# DEVELOPMENT REVIEW BOARD REPORT

Meeting Date: January 5, 2017 Item No. 6  
General Plan Element: *Character and Design*  
General Plan Goal: *Foster quality design that enhances Scottsdale as a unique southwestern desert community.*

### **Greenway Hayden Loop Apartments 43-DR-2016**

**Request:** Request approval of the site plan, landscape plan, and building elevations for a new mixed-use development comprised of two, four-story buildings with 581,509 square feet of building area containing 622 residential units and 22,025 square feet of non-residential space on an 8.84 net-acres site.

**BUILDING ELEVATIONS**  
**BUILDING #1 ELEVATIONS**  
 1/16" = 1'-0"

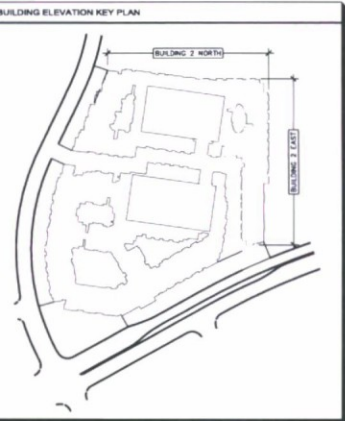
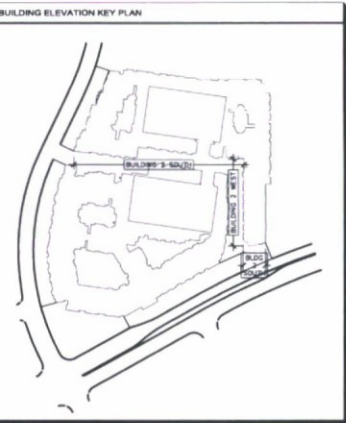
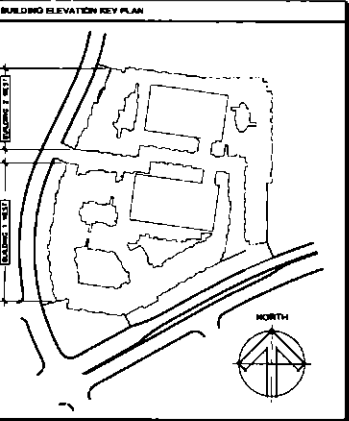
2. All exterior window glazing shall be recessed a minimum of fifty (50) percent of the wall depth, including glass windows within any tower/clerestory elements. The amount or recess shall be measured from the face of the exterior wall to the face of the glazing, exclusive of external detailing. With the final plan submittal the developer shall provide head, jamb, and sill details clearly showing the amount of recess for all window types.

3. All exterior doors shall be recessed a minimum of thirty (30) percent of the wall depth, the amount of recess shall be measured from the face of the exterior wall to the face of the glazing, exclusive of external detailing. With the final plan submittal the developer shall provide head, jamb, and sill details clearly showing the amount of recess for all door types.

ELECTRICAL  
SITE PLAN  
1"=40'-0"

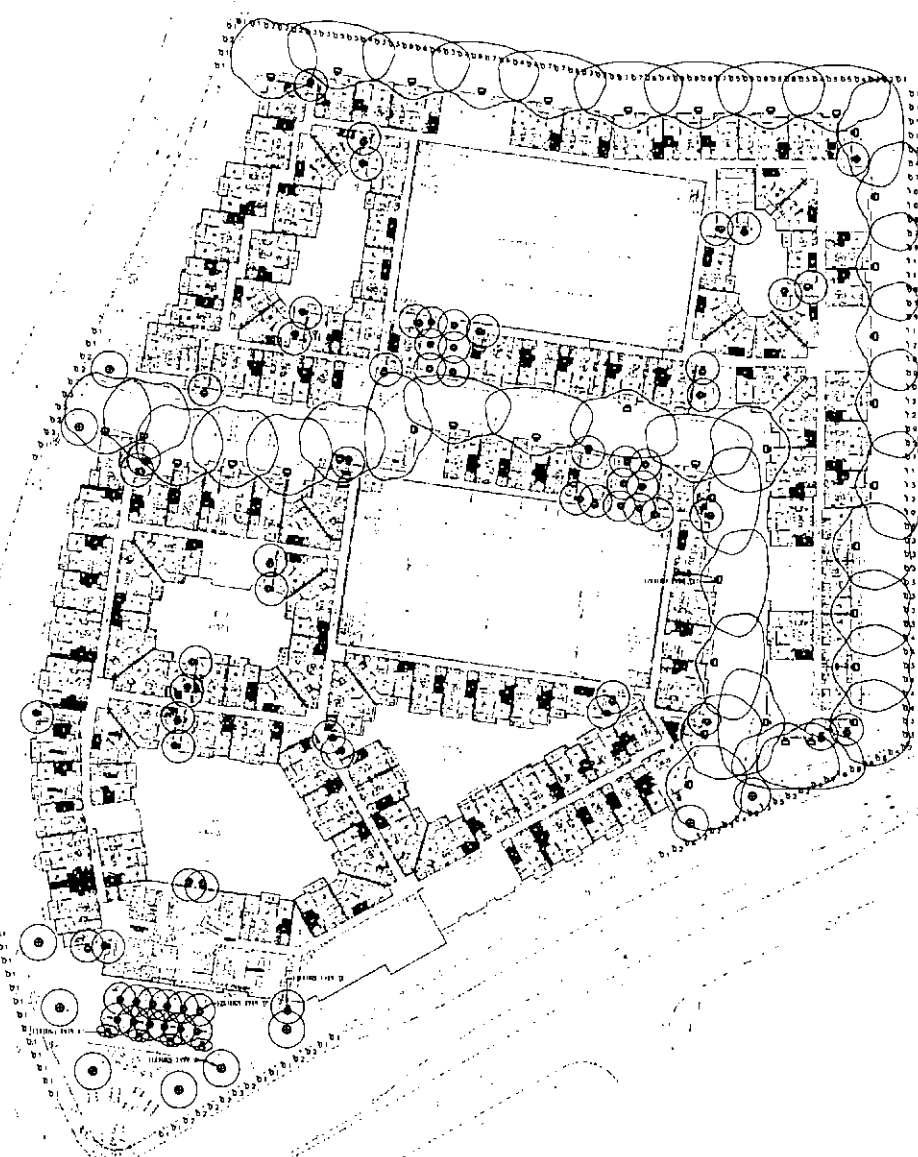
- b. The location and configuration of all site improvements shall be consistent with the site plan submitted by Biltform Architecture, with a city staff date of 10/31/16.
